**Product Change Notification / CENO-17EGOL207**

CCB 5097 Final Notice: Qualification of MTAI as an additional final test site for selected SST39SF040, SST39SF020A and SST39SF010A device families available in 32L PLCC (11.5x14x3.37mm) package.

**CCB 5097**  
**Pre and Post Change Summary**  
**PCN #: CENO-17EGOL207**

# Pre and Post Change Summary – Pin 1 Orientation

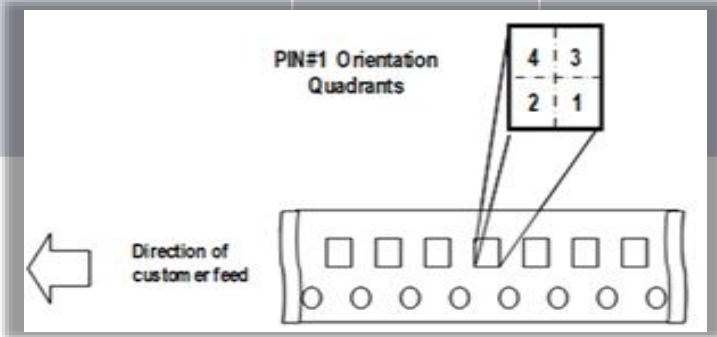
KYE	MTAI
Pin 1 Orientation	Tape and Reel		
		Quadrant 1- 2	Quadrant 1- 2

# Pre and Post Change Summary – Carrier Tape

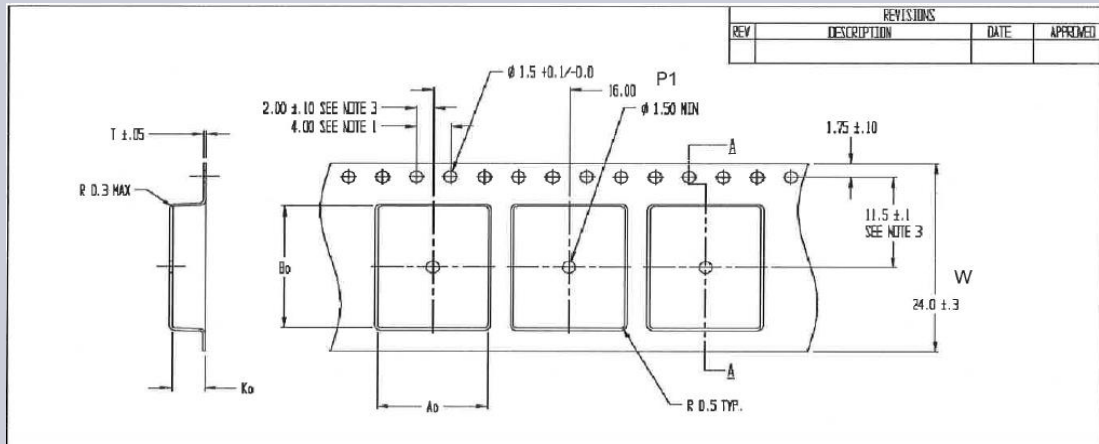
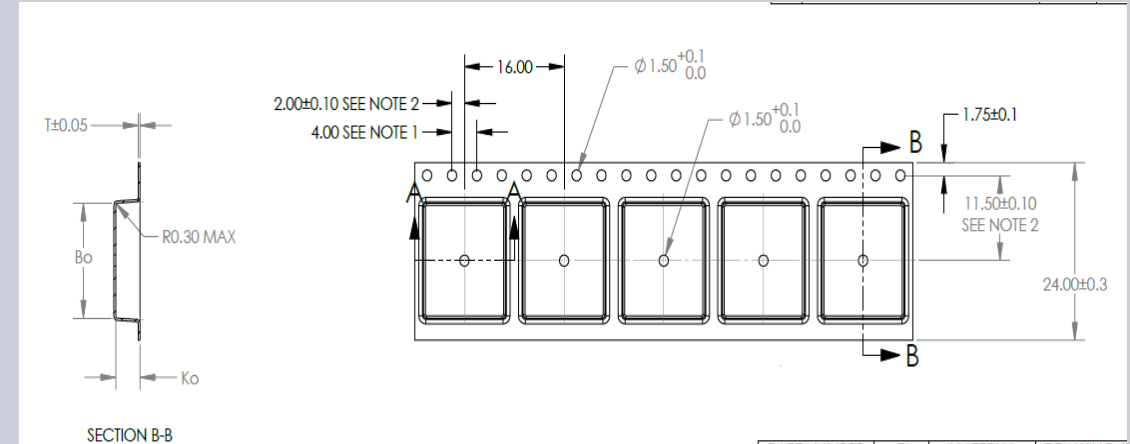
Scan / Pack Site	W (mm.)	P (mm.)	A0 (mm.)	B0 (mm.)	K0 (mm.)	K1 (mm.)	Thickness	BQM
MTAI	24.00 $\pm$ 0.30	16.00 $\pm$ 0.10	13.10 $\pm$ 0.10	15.50 $\pm$ 0.10	3.90 $\pm$ 0.10	-	0.30 $\pm$ 0.50	750
KYE	24.00 $\pm$ 0.30	16.00 $\pm$ 0.10	13.10 $\pm$ 0.10	15.50 $\pm$ 0.10	3.90 $\pm$ 0.10	-	0.30 $\pm$ 0.05	750

# Pre and Post Change Summary – Cover Tape

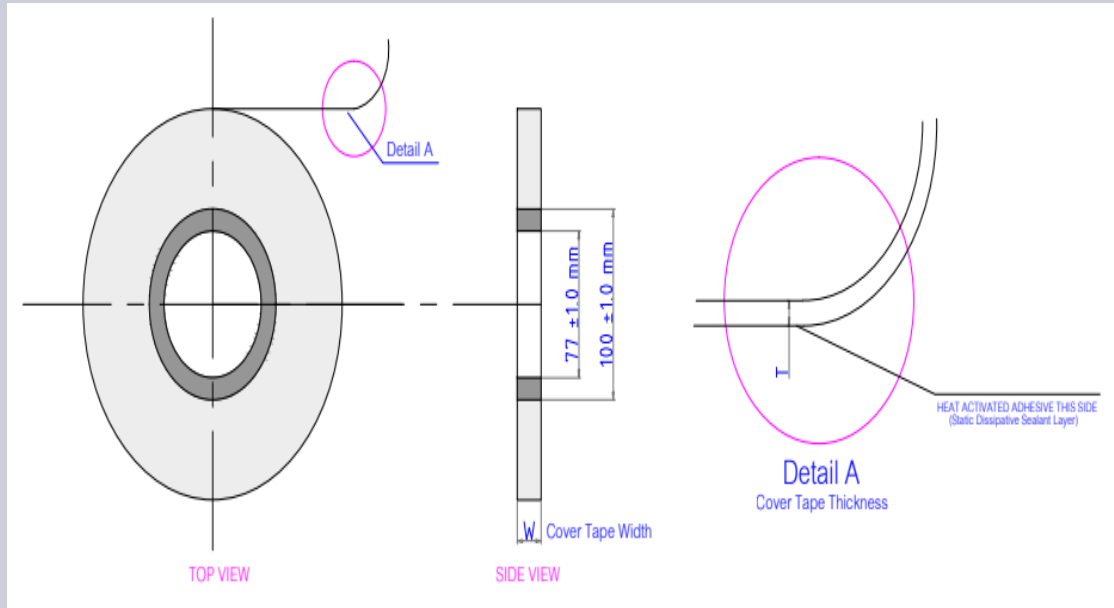
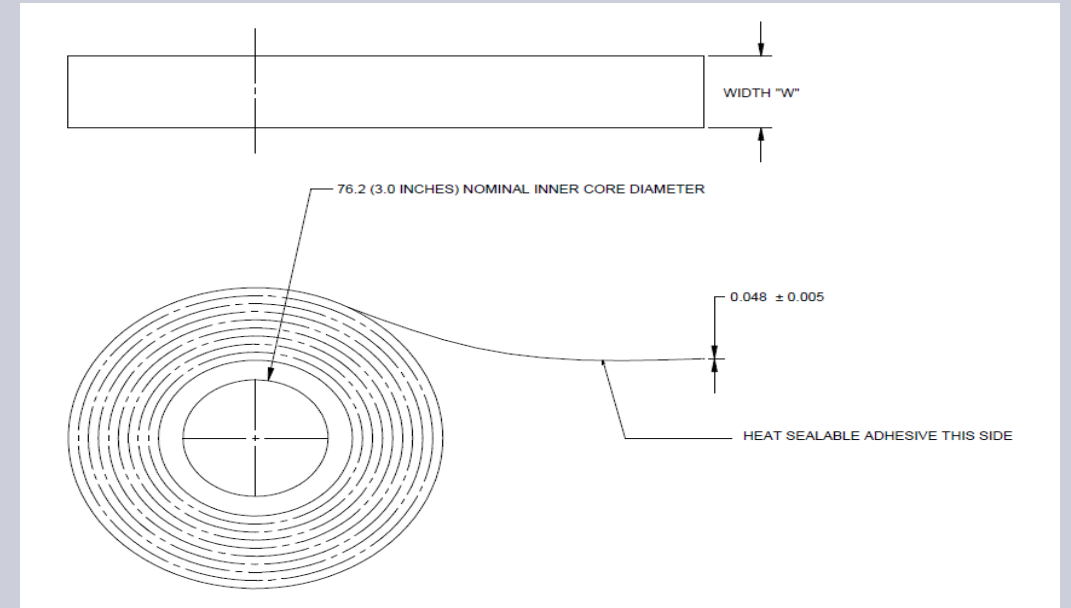
Cover tape color	Width $\pm 0.1$ (mm)	Thickness $\pm 0.005$ (mm)	Sealing Methodology
Transparent	$21.3 \pm 0.1$	$0.048 \pm 0.005$	Heat Seal

Cover tape color	Width $\pm 0.1$ (mm)	Thickness $\pm 0.005$ (mm)	Sealing Methodology
Clear	$21.0 \pm 0.1$	$0.050 \pm 0.010$	Heat Seal

# Pre and Post Change Summary – Plastic Reel

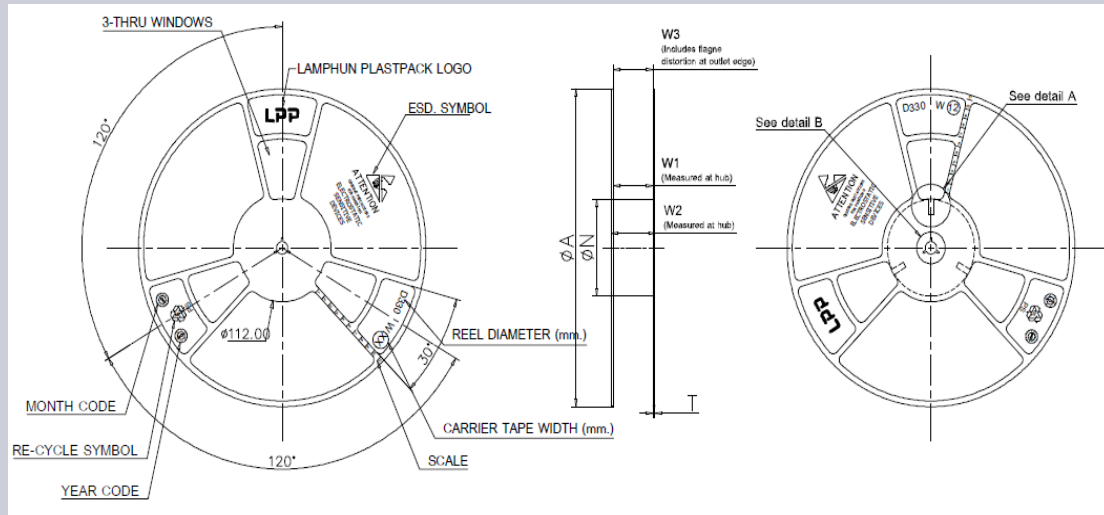
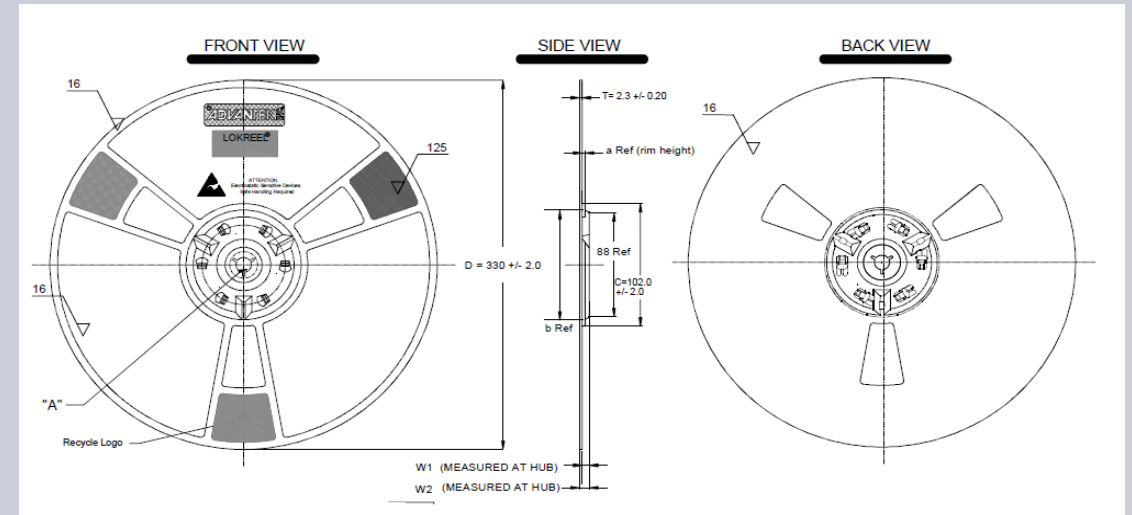
Reel Color	Reel diameter (mm)	Hub (mm)	Reel Width Max (mm.)
Regrind Blue	330 ±2.0	102±2.0	8.4 + 16.4

Reel Color	Reel diameter (mm)	Hub (mm)	Reel Width Max (mm.)
Dark Blue	330 ±2.0	100 ±2.0	30.40
